CITY OF MARGATE

DEVELOPMENT REVIEW COMMITTEE (DRC) REVIEW #2

PROJECT NAME:		Dunkin Donuts		
PROJECT NUMBER:		2021-401		
PROJECT LOCATION:		7300 Royal Palm Boulevard		
APPLICANT/AGENT:		Dennis D. Mele, Esq. Greenspoon Marder LLP		
REVIEW/APPLICATION		Special Exception		
DISCIPLINE			EMAIL	TELEPHONE
DRC Chairman	Elizabeth Taschereau – Director		etaschereau@margatefl.com	(954) 884-3686
Planning	Andrew Pinney – Senior Planner		apinney@margatefl.com	(954) 884-3684
Planning	Alexia Howald – Associate Planner		ahowald@margatefl.com	(954) 884-3685
Building	Richard Nixon – Building Official		rnixon@margatefl.com	(954) 970-3004
Engineering	Curt Keyser – Director		ckeyser@margatefl.com	(954) 884-3631
Engineering	Randy L. Daniel – Assistant Director		rdaniel@margatefl.com	(954) 884-3633
Fire	David Scholl – Fire Department		dscholl@margatefl.com	(954) 971-7010
Public Works	Mark Collins – Director		mcollins@margatefl.com	(954) 972-8126
Public Works	Gio Batista – Assistant Director		gbatista@margatefl.com	(954) 972-8123

I		
PROJECT NAME:		Dunkin Donuts		
PROJECT NUMBER:		2021-447		
PROJECT LOCATION:		7300 Royal Palm Boulevard		
APPLICANT/AGENT:		Dennis D. Mele, Esq. Greenspoon Marder LLP		
REVI

[Photos linked to comments that were withdrawn due to adoption of Ordinance 2022-08.]

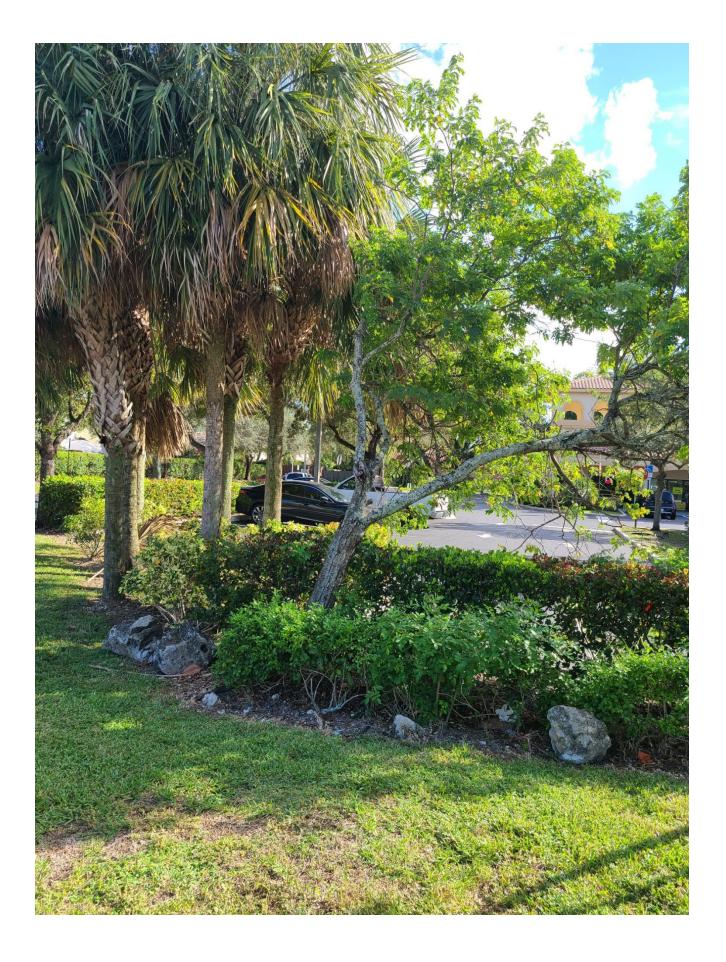
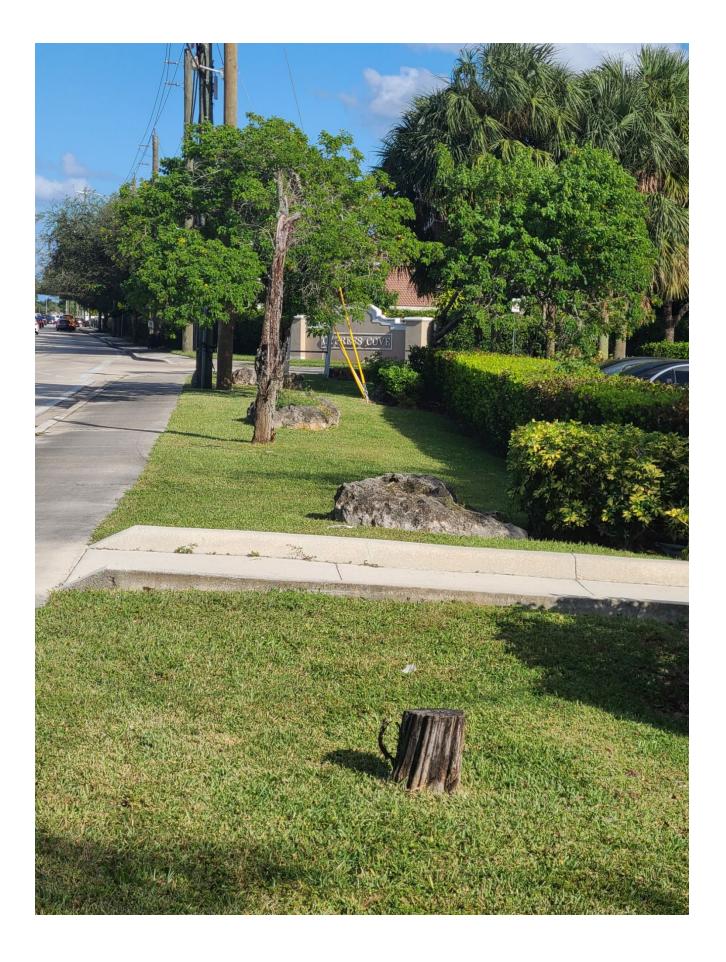
<u>COMMENT 3</u>: A planting bed of at least 2 feet in width shall surround any monument and/or freestanding sign and shall be maintained to a maximum height of twelve (12) inches per Section 39.6(A)(8) of the Margate Zoning Code. See photos. (Comment withdrawn due to adoption of Ordinance 2022-8 on 6/1/2022)

<u>COMMENT 10:</u> A hedge shall be planted within the landscape right-of-way perimeter buffer strip and parallel with the street. Existing landscape hedge has sections that are dead. Indicate on the landscape plan proposed replacement hedges meeting Section 23-6(B)(1) of the Code of the City of Margate. See photos. (Comment withdrawn due to adoption of Ordinance 2022-8 on 6/1/2022)

<u>COMMENT 12:</u> Landscaping shall be maintained such that it will not cause property damage and public safety hazards, including removal of living, dead or decaying plant material, tree stumps, removal of low hanging branches below twelve (12) feet above grade and those obstructing street lighting. Existing trees are blocking stop signs and street lighting. Provide a note on the plans where trees will be trimmed to meet minimum standards of Section 40.9 of the MZC. See photos. (Comment withdrawn due to adoption of Ordinance 2022-8 on 6/1/2022)
